ADDENDUM NO. 2

Project: Miracle of Hickory Park - Modification
City of Hickory, North Carolina

Date: September 21, 2026

Miracle of Hickory Park – RFIs

C400

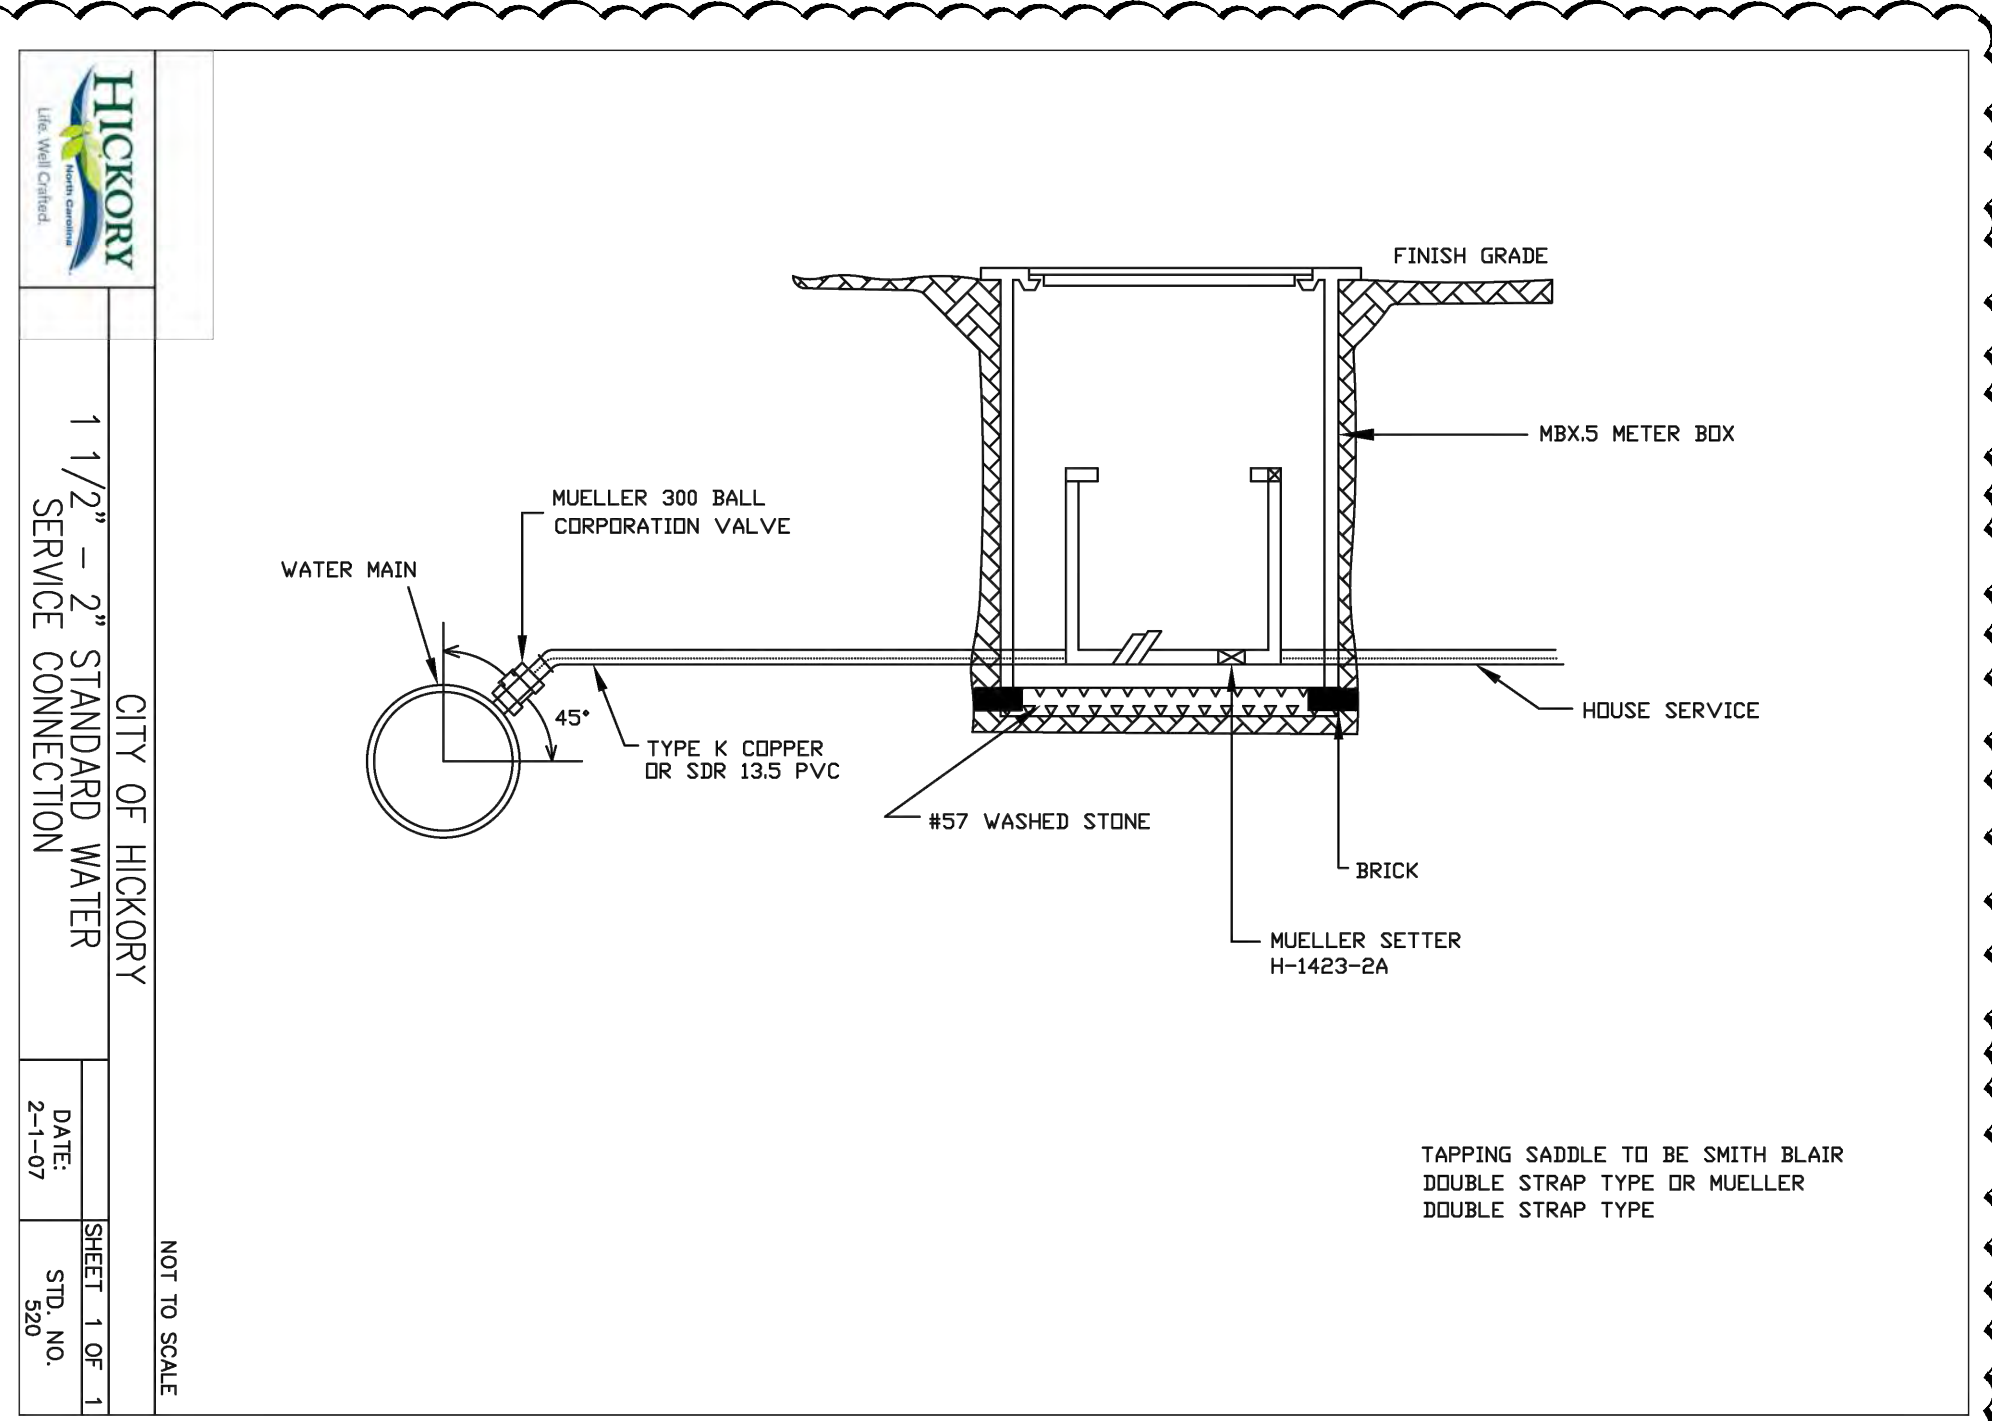
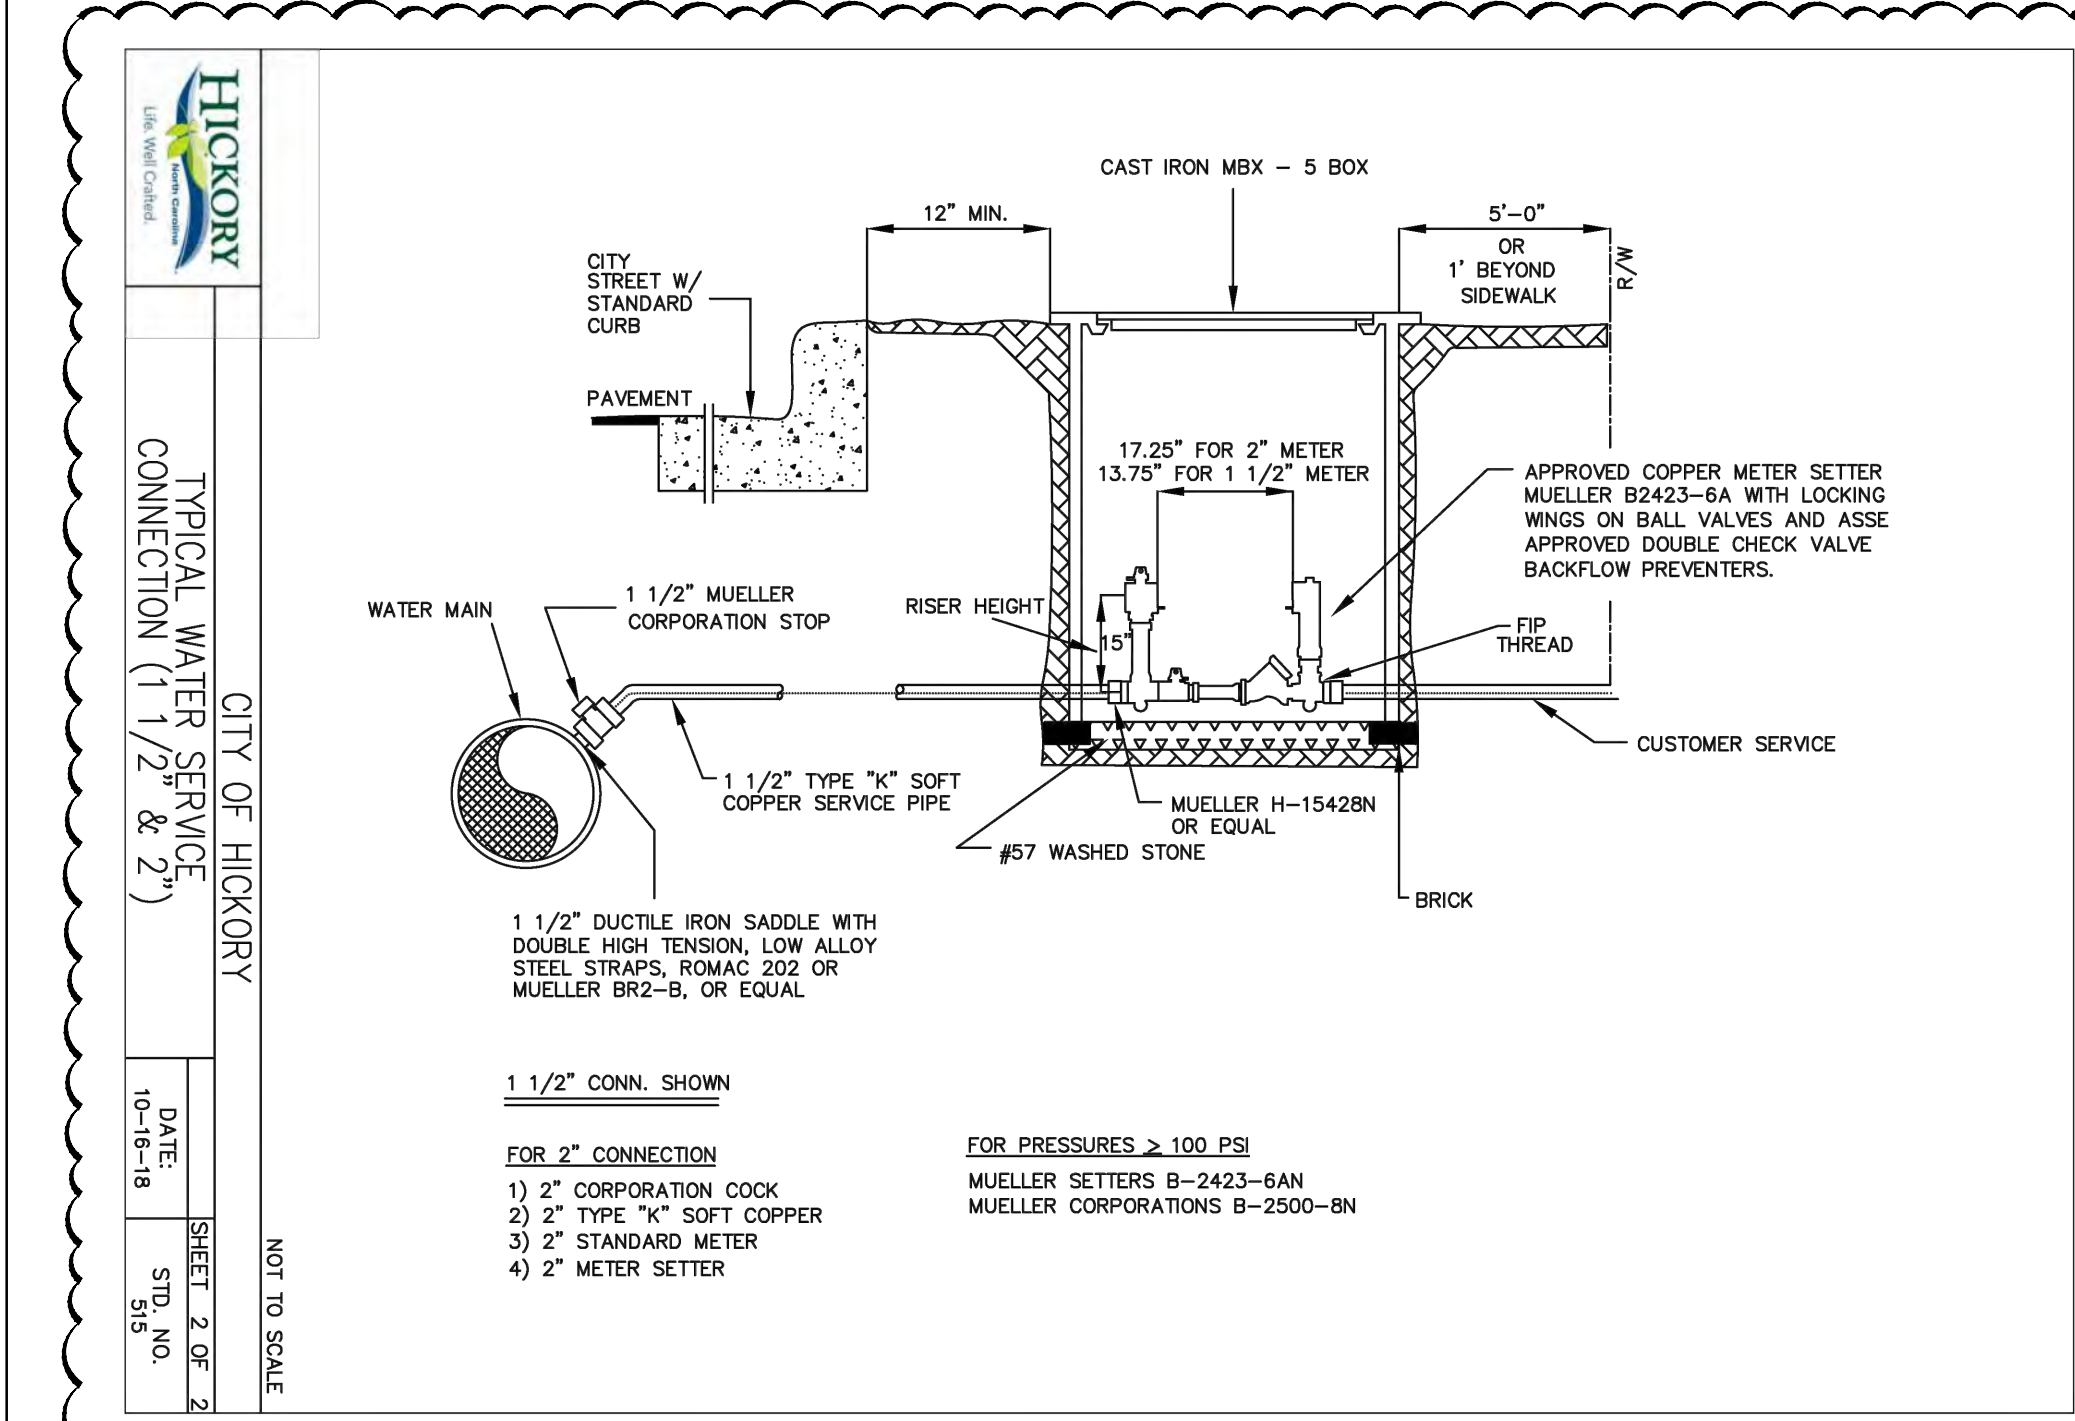
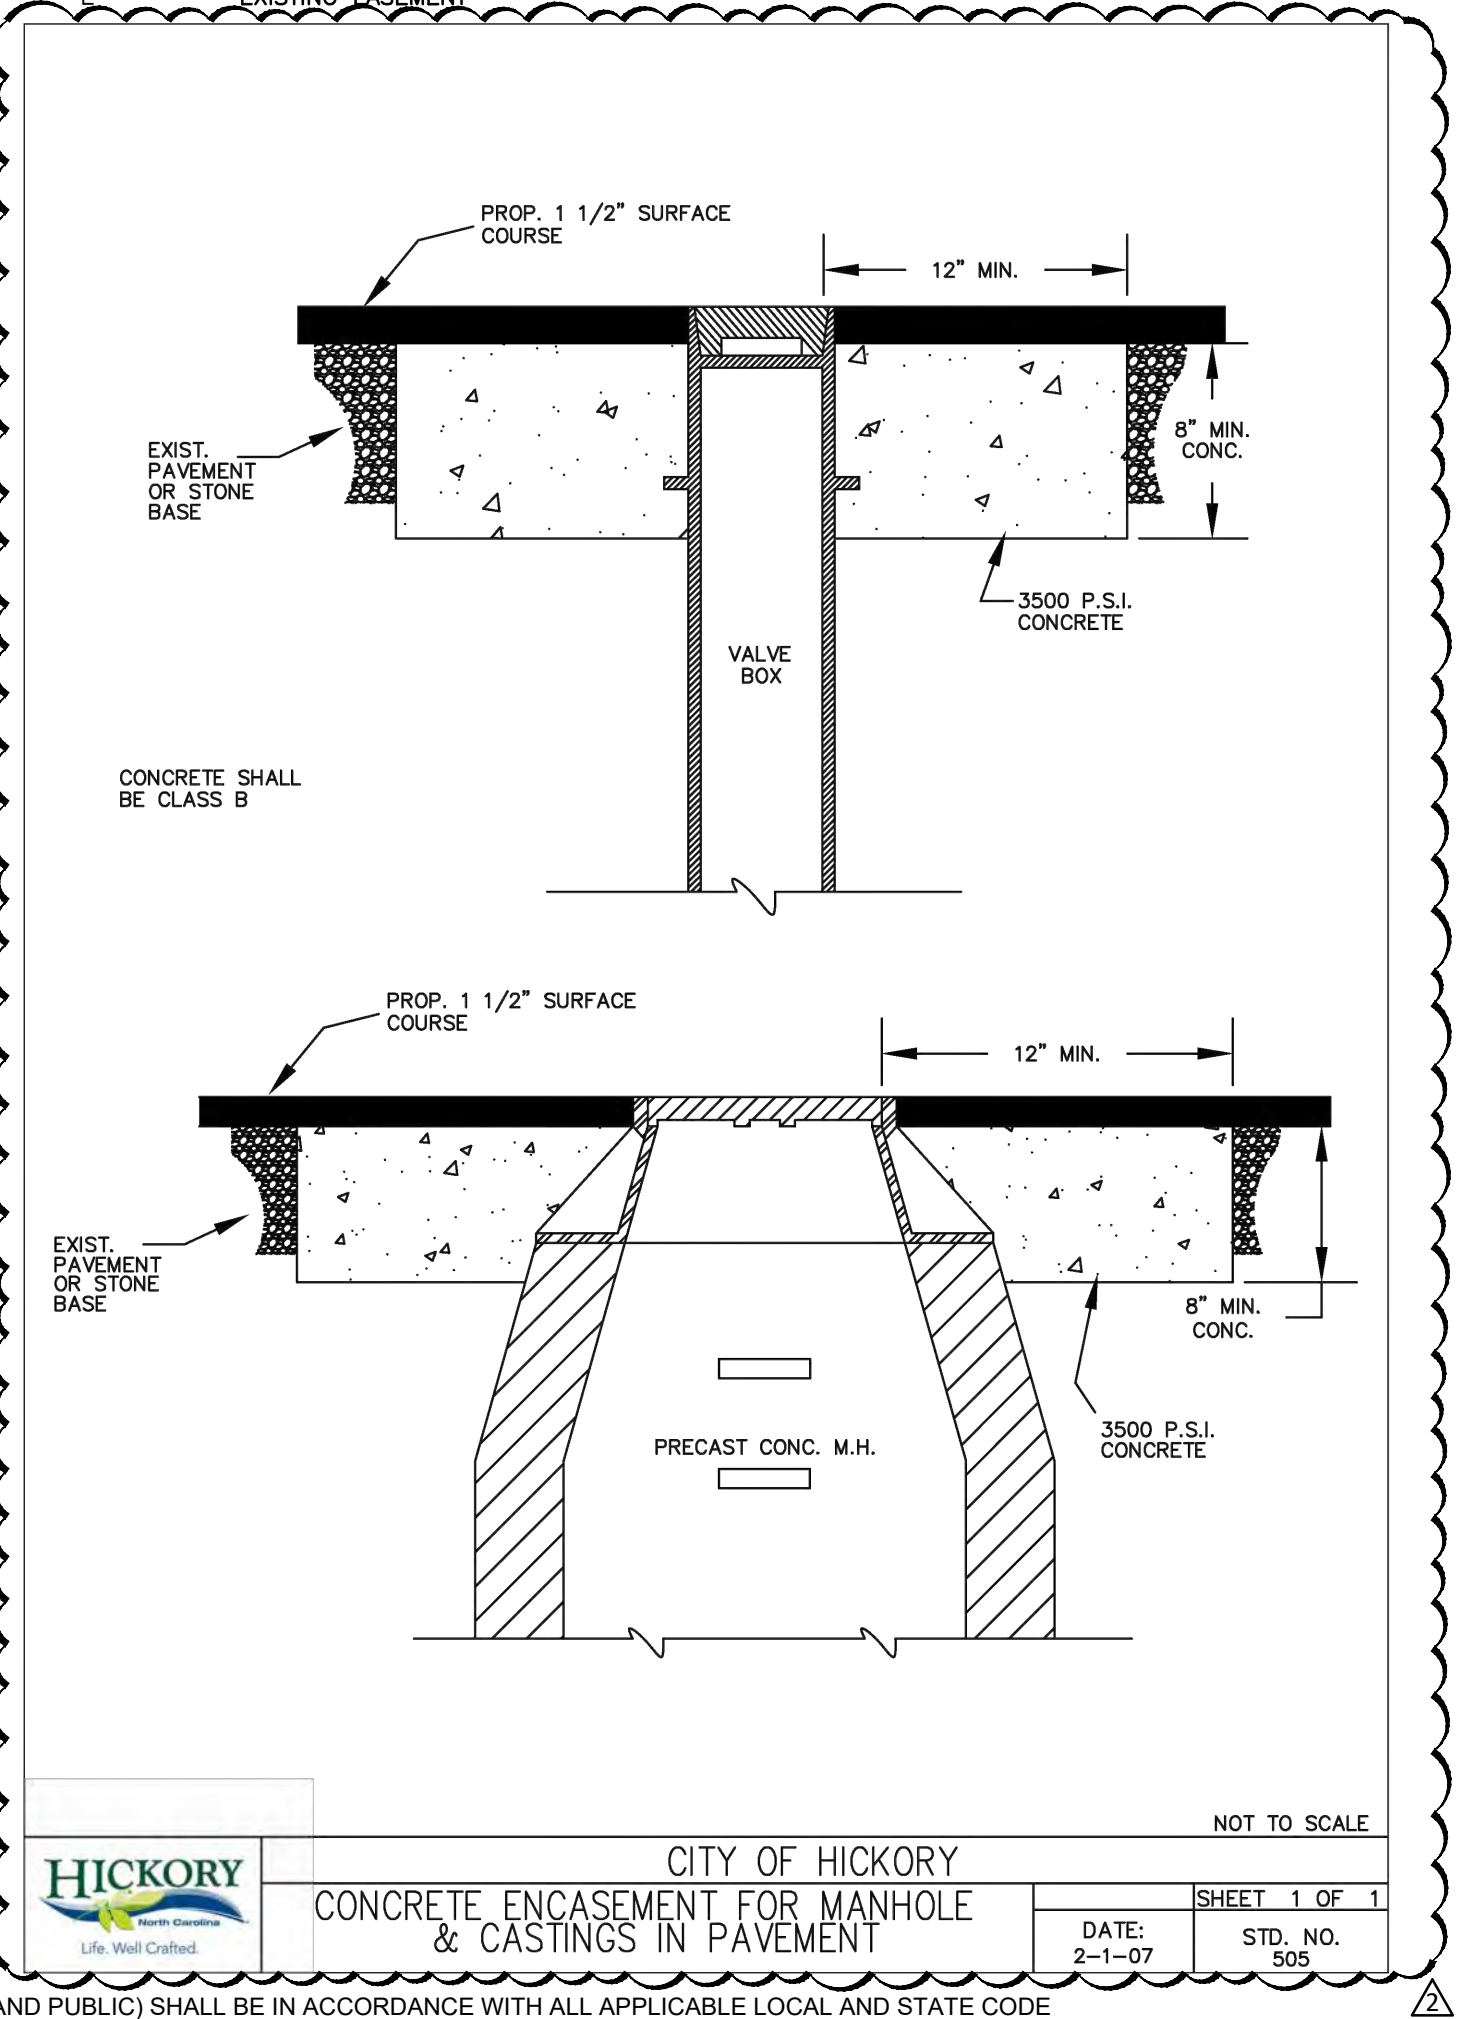
1. Based on a site meeting held on 9/18/26 between City of Hickory Engineering and City of Hickory Utilities we are going to need to run a new 1 ½" water service line from the watermain on 12th St. Dr. NE to the new restroom building. Preferably with the alignment staying primarily in the grass strip between the Music Factory parking lot and the Army Reserve parking lot. This will require a new water tap and meter. See revised sheet C400. The backflow preventor and pressure reducing valve are shown on the revised plumbing sheet P1.
2. The line items for the restroom building have been split into two items on the bid form.
3. A series of questions have been received and are responded to below:
